ADDENDUM

ADDENDUM NUMBER: One **DATE:** October 26, 2023

RE: NPHC Plaza
 Austin Peay State University
 SBC Project No. 373/003-03-2023

A1.1
SHEET NO.

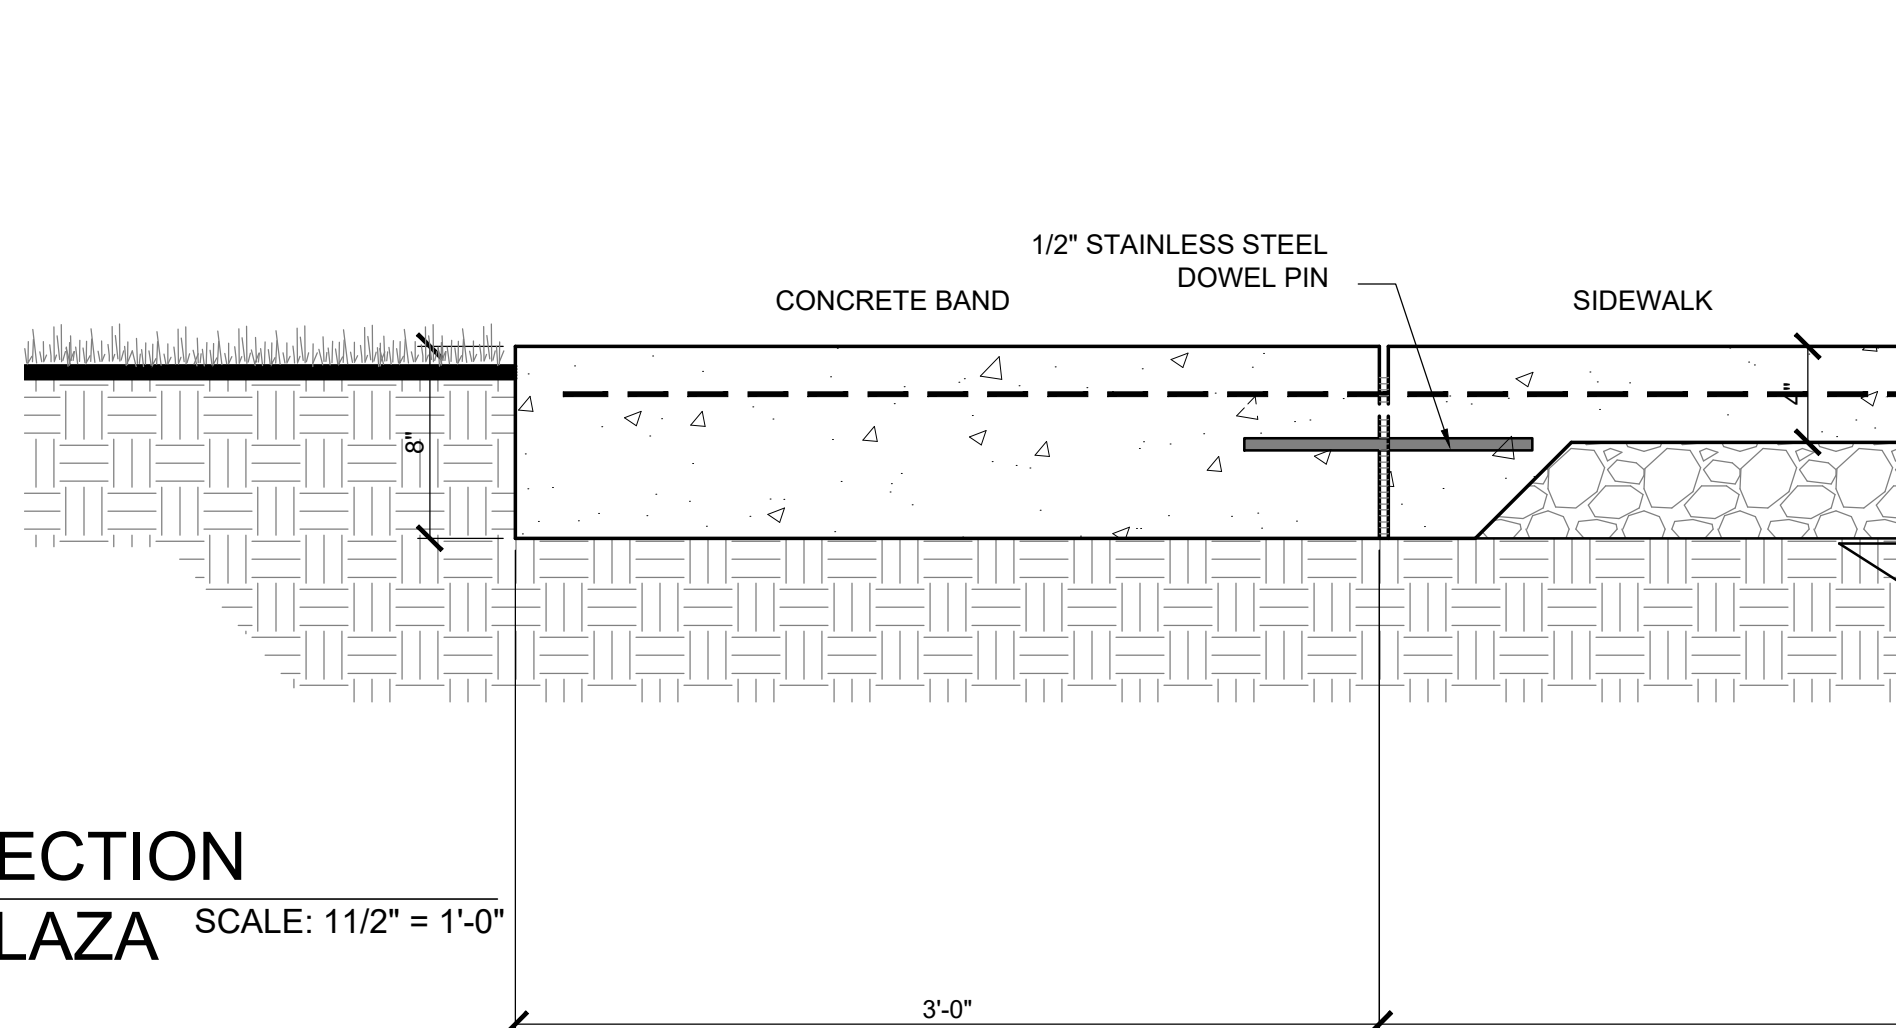
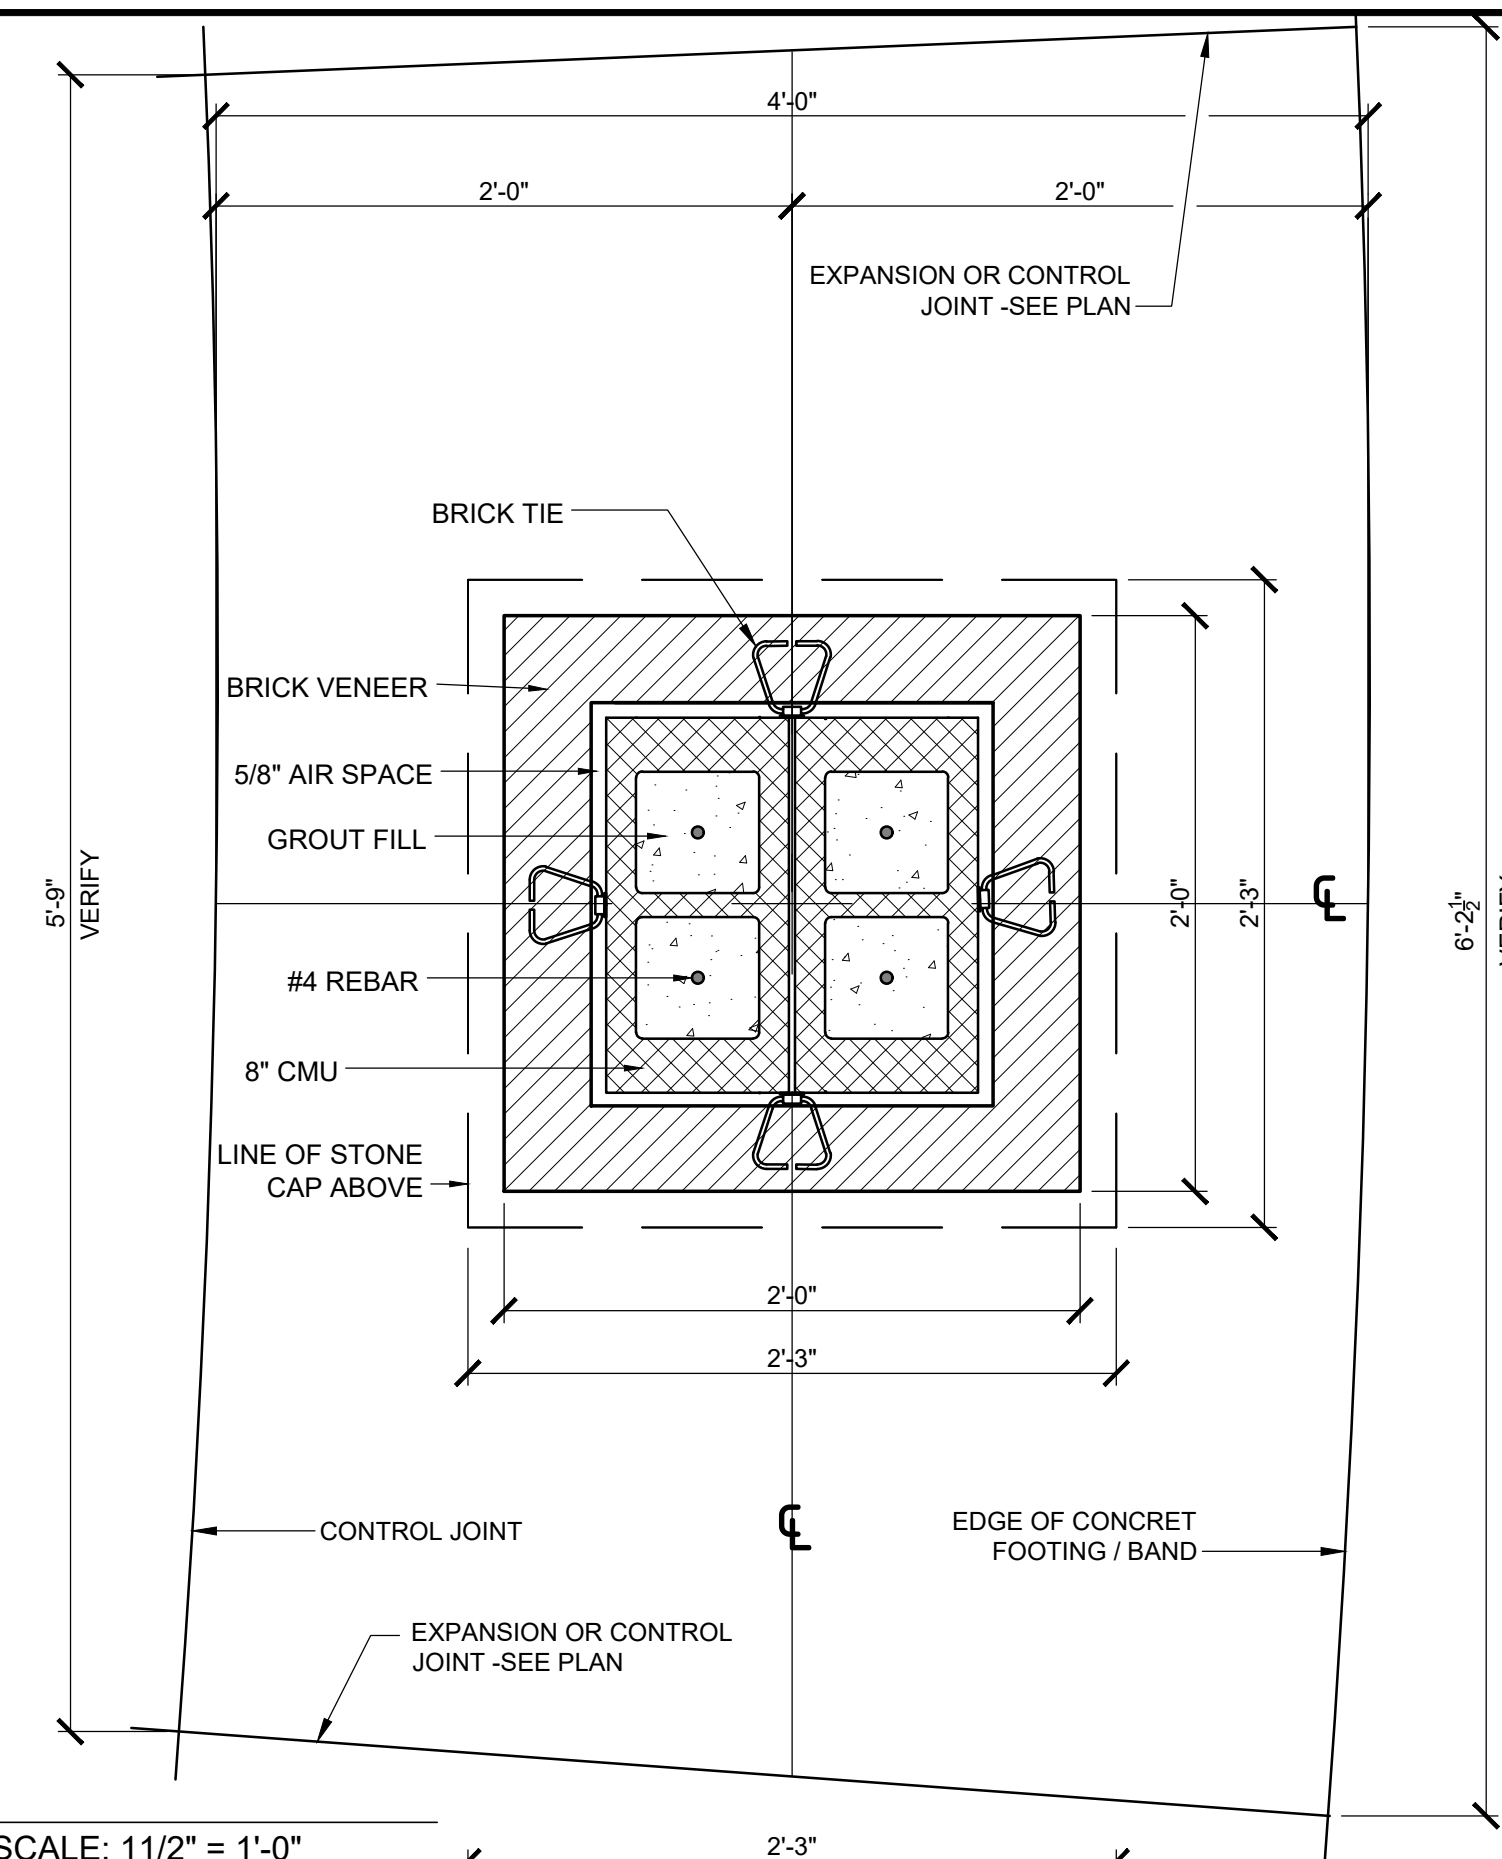
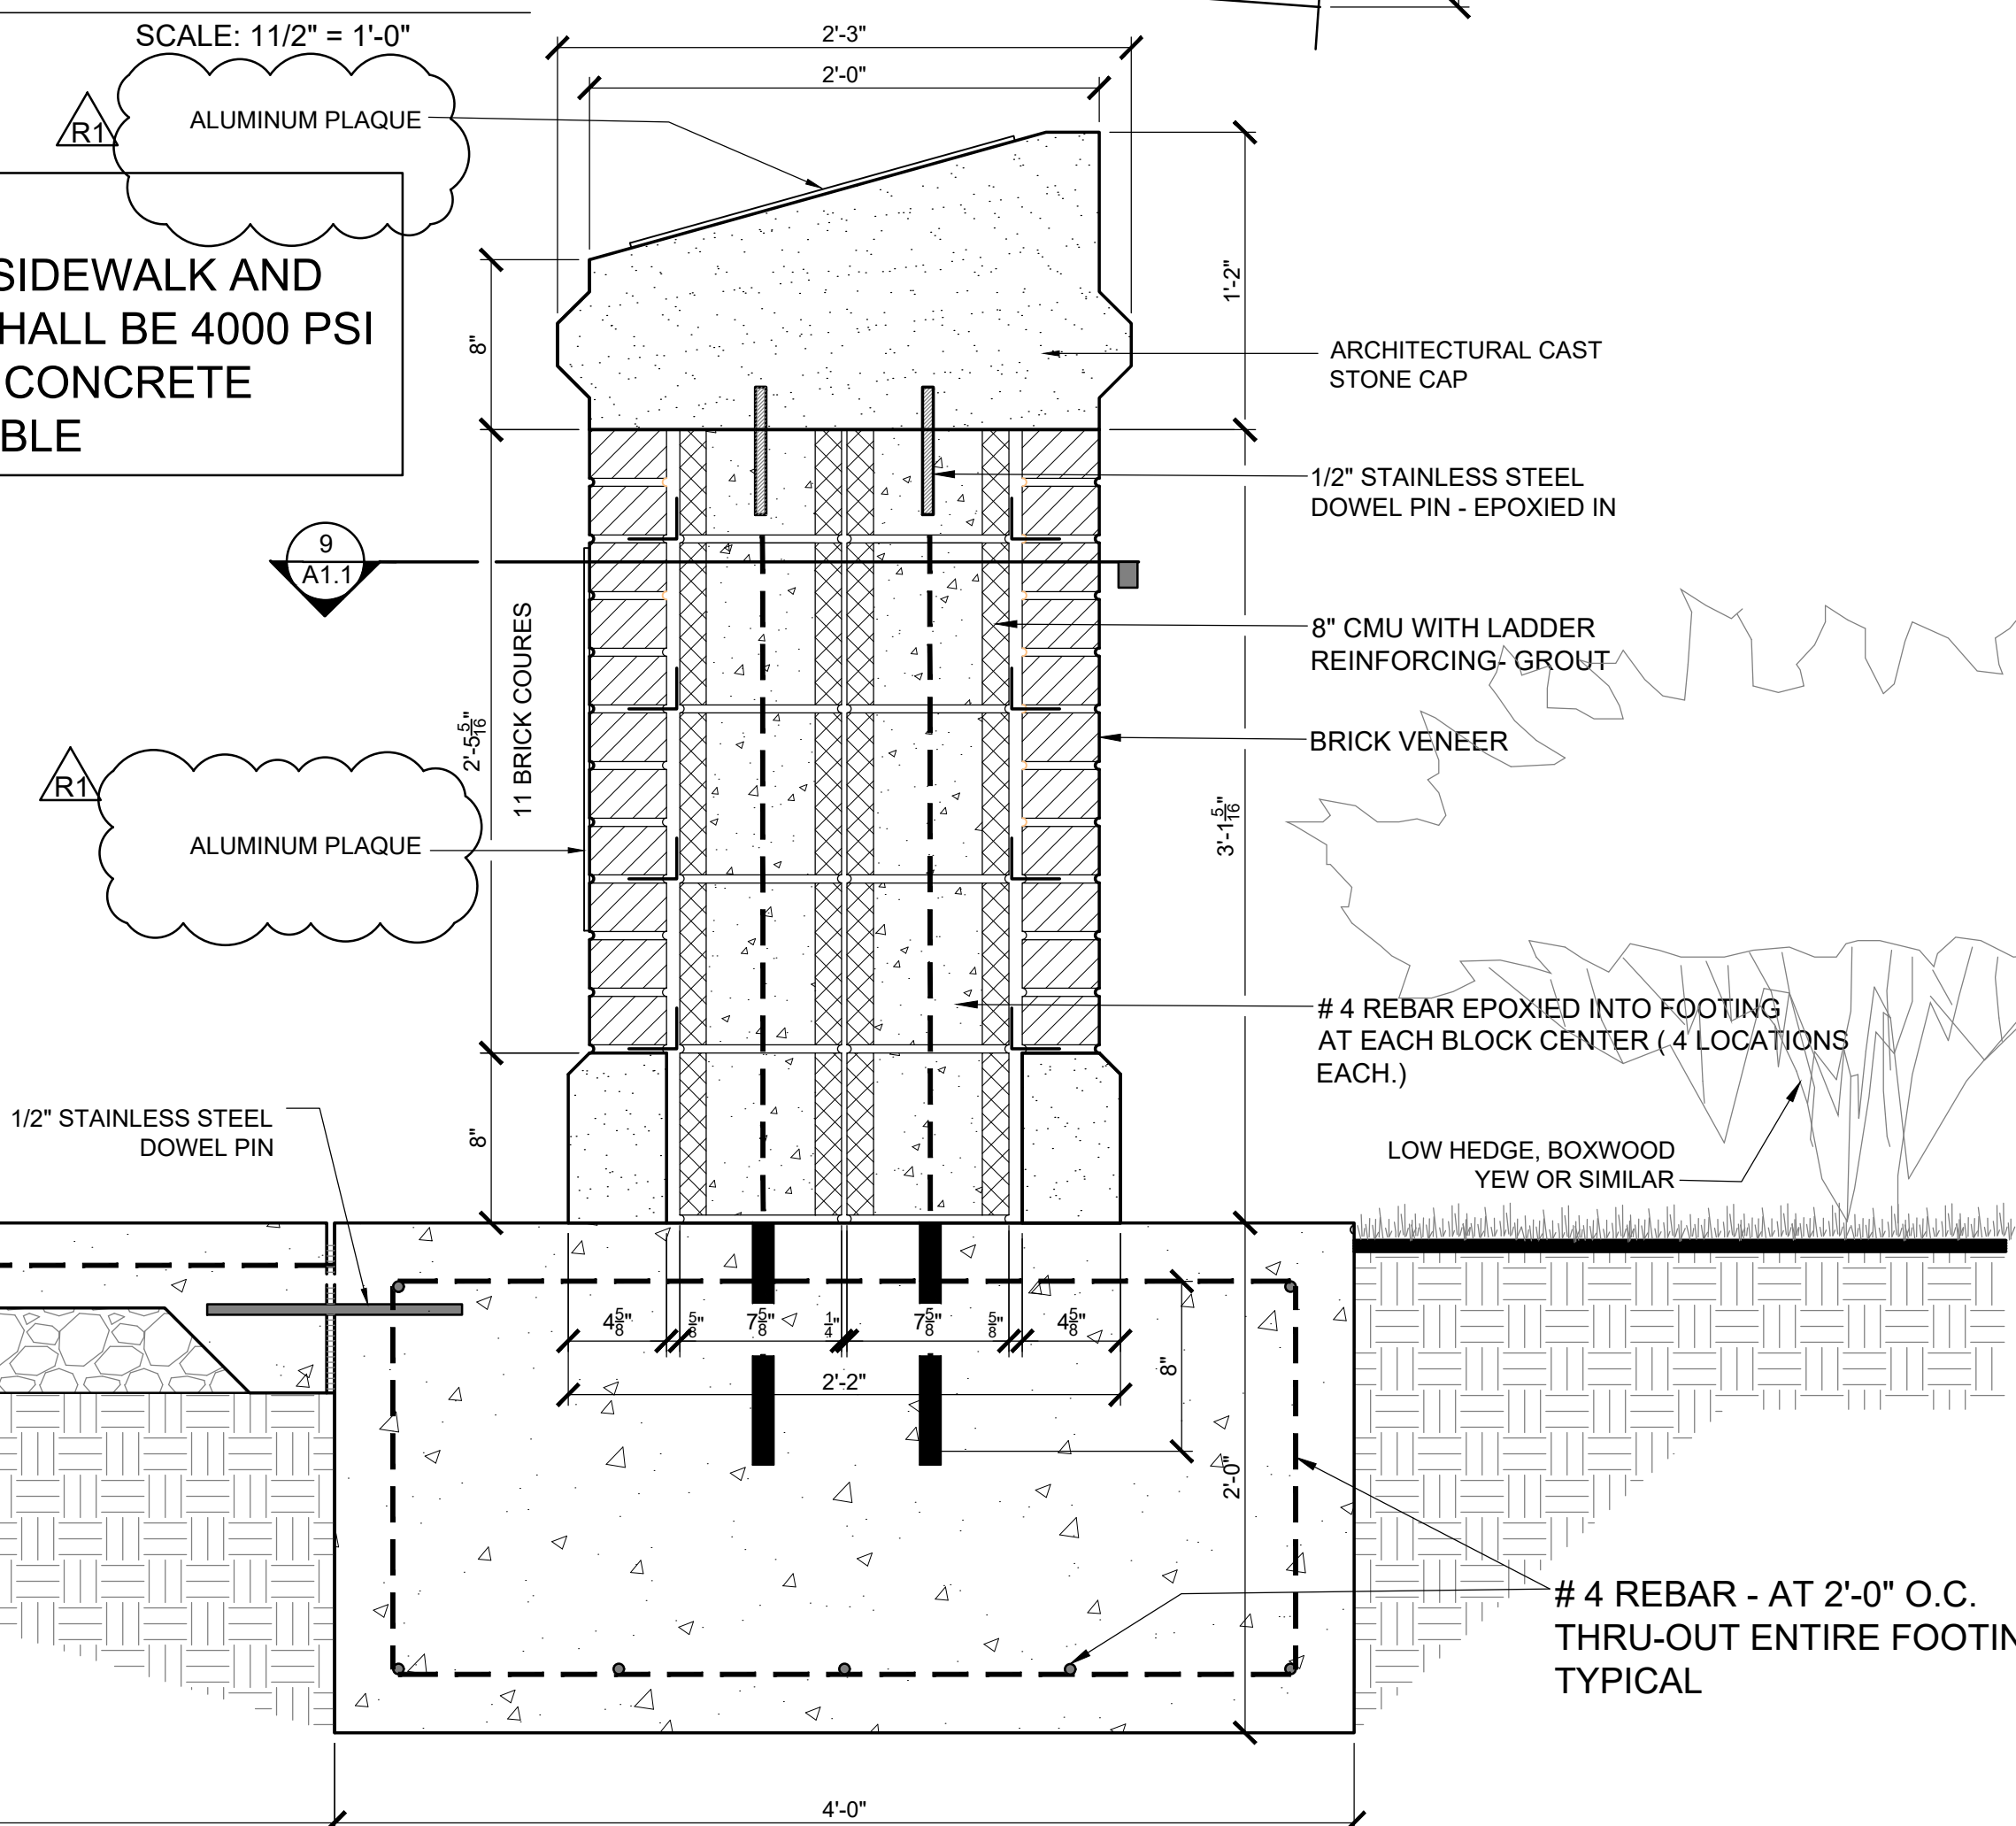
VI-1 Reference Sheet A1.0 Site Plan and Details, and Sheet A1.1 Details.
Delete original drawing sheets and replace with revised sheets A1.0 and A1.1. Revisions include: replacing originally specified bronze plaques with cast aluminum plaques as the Basis of Design.
